MFN No. 128-94
Docket No. STN 52-004

Subject: **NRC Requests for Additional Information (RAIs) on the
Simplified Boiling Water Reactor (SBWR) Design**

Fuel Performance Testing

RAI Number: 900.63

Figure 900.64-1 Critical Quality vs. Boiling Length, Freon-114 Annulus Data

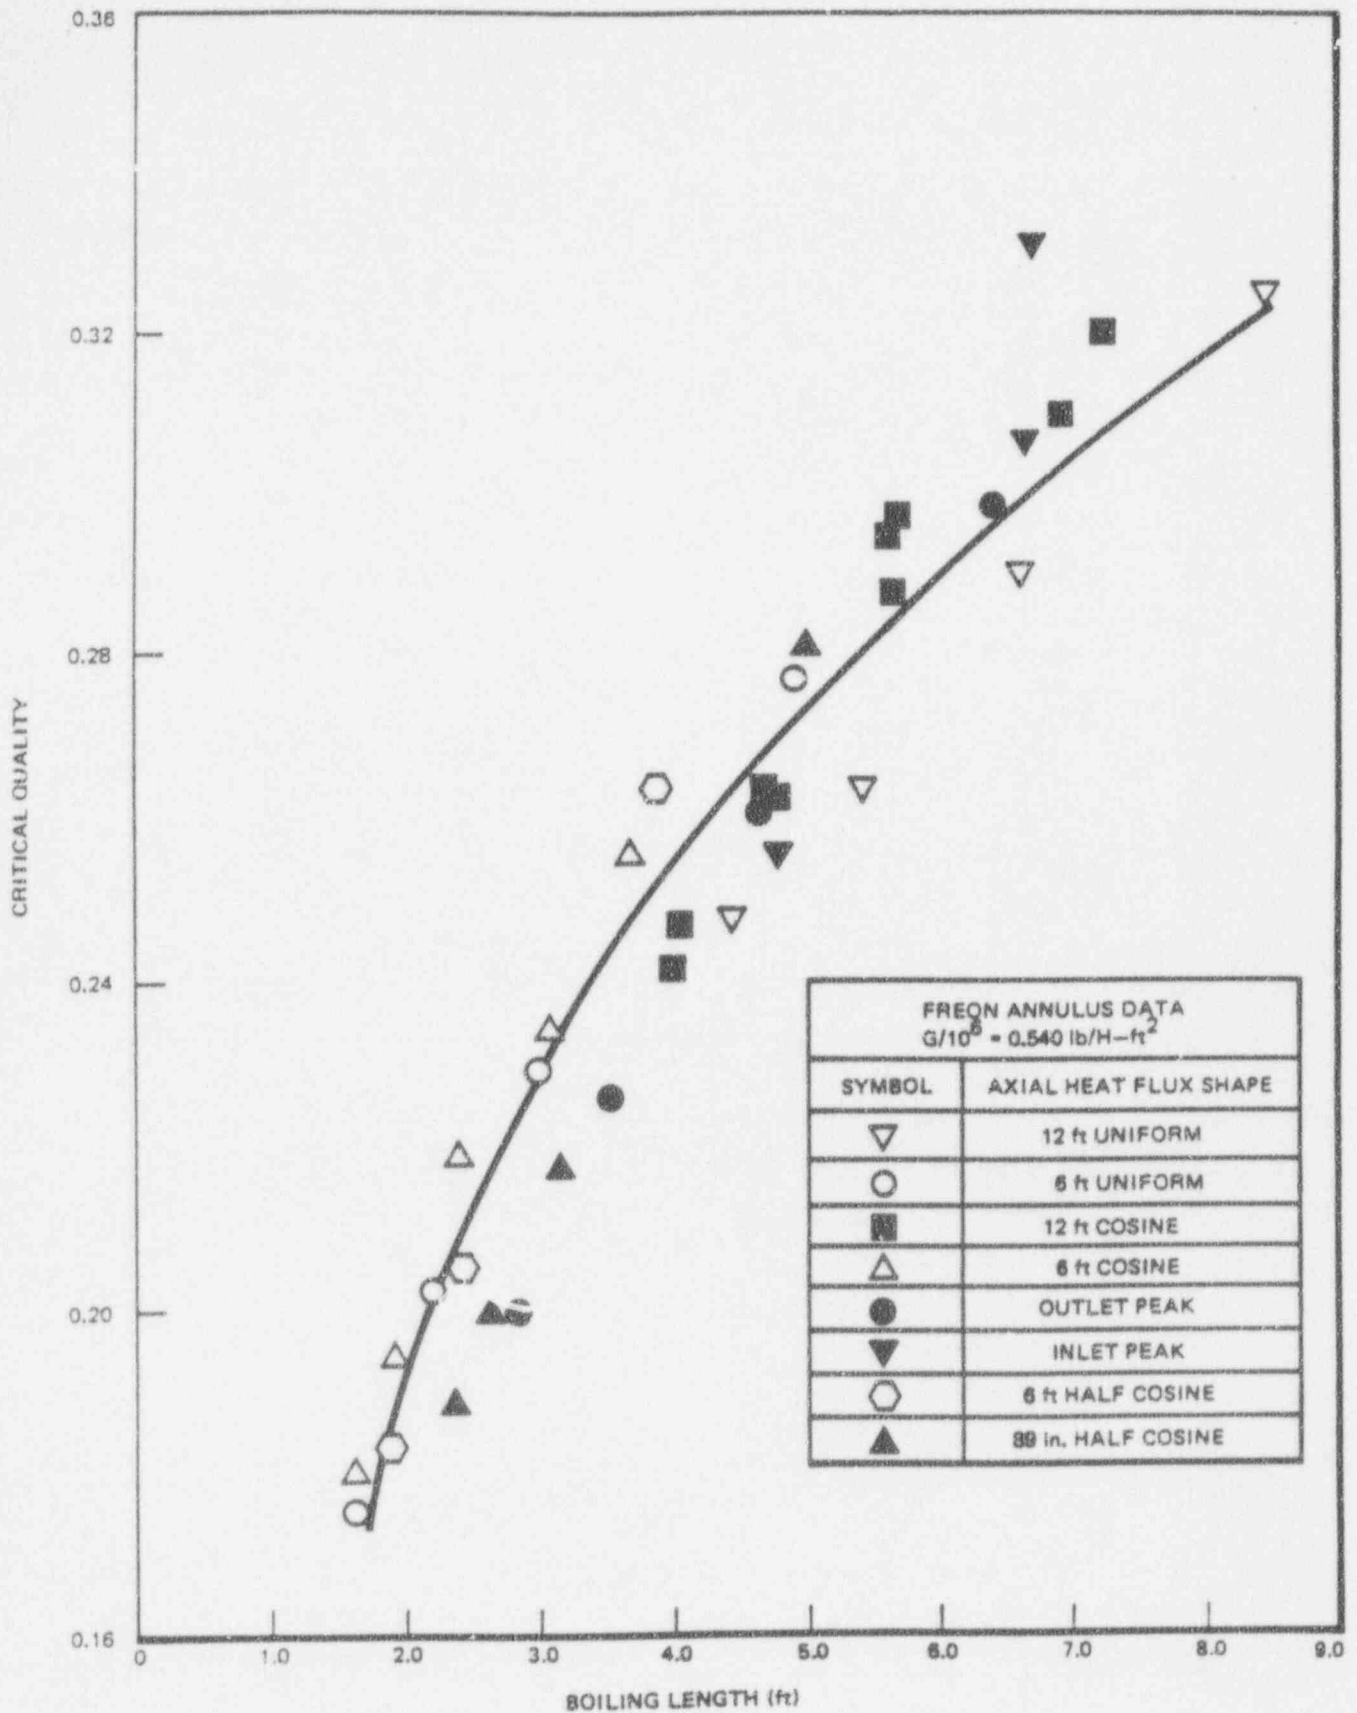
- a. Detailed information to support GE's conclusion that the code and the model are applicable over the range of geometric (e.g., fuel length, pitch, diameter, spacer configuration) and the thermal-hydraulic (e.g., mass flow rate, power profile) parameters representative of the SBWR fuel design.
- b. Provide details of the planned testing, including the test specification, test matrix, and test schedule.
- c. Provide details of the analyses planned in conjunction with the fuel performance test program, including documentation for the thermal-hydraulic correlations to be validated for use in SBWR safety analyses.
- d. Provide verification that the ATLAS facility is able to match approximately the appropriate thermal-hydraulic conditions for SBWR fuel. In particular, how will ATLAS simulate the natural circulation flow behavior that will exist in the SBWR?

First, it should be recognized that the boiling length type of correlation is well suited to predict the effects of length and axial power shape. This was one of the main reasons it was chosen to replace the local conditions based CHF correlation. Figure 900.64-1 shows data from various 6 ft and 12 ft lengths correlated by the boiling length correlation. The GEXL01 correlation (which preceded GEXL02 and is of similar form) included in its data base 84 data points with a 16 rod bundle with a 6 foot heated length.
